Staff Report
City of Richmond, Virginia

Commission of Architectural Review

| 1. COA-109599-2022 | Final Review | Meeting Date: 4/26/2022 |
| Project Description | Replace front and rear wooden porch railings with aluminum. | |

Figure 2. Existing front porch with wood railings

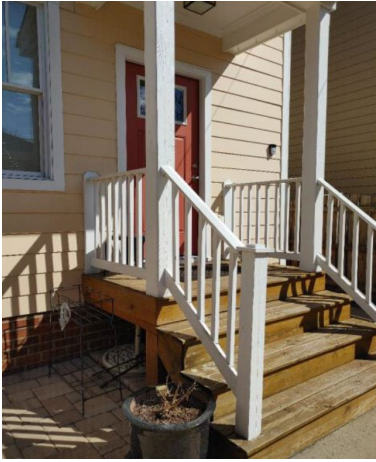
| Guideline Reference | Reference Text | Analysis |
|---------------------------------|---|--|
| Substitute Materials #3, pg. 61 | <i>The problems associated with the use of poor quality original materials can be remedied by in-kind replacement. If in-kind materials cannot be found, or are impractical, substitute materials can be use.</i> | Through photo documentation the applicant has demonstrated that the existing railings are deteriorated. The owners of the units wish to replace them with a more durable material as the longevity of the wood was not as long as expected. Staff is supportive of the |

| | | installation of a more durable substitute material. |
| Porches & Porch Details, pg. 49 | <p><i>2. When designing a new railing for a new infill building, or for an existing building which has lost its railing and for which no documentary or physical evidence survives, the balusters in the traditional Richmond rail are generally rectangular in section (with the narrow dimension facing the street) or square. The baluster is fitted into the recess in the top rail and a sloped bottom rail. Typical deck railings, consisting of nailed-up stock elements, are not approved as they are not based on a compatible historical model found in Richmond's Old and Historic Districts.</i></p> <p><i>3. New porch railing designs, compatible with the overall design of the building, will also be considered.</i></p> | <p>The applicant proposes to replace rotted wooden porch railings on the front and rear with aluminum railings. The aluminum railings will have the appearance of Richmond rail and the design is compatible with the overall design of the building. <u>Staff recommends approval of the installation of front and rear metal railings.</u></p> |
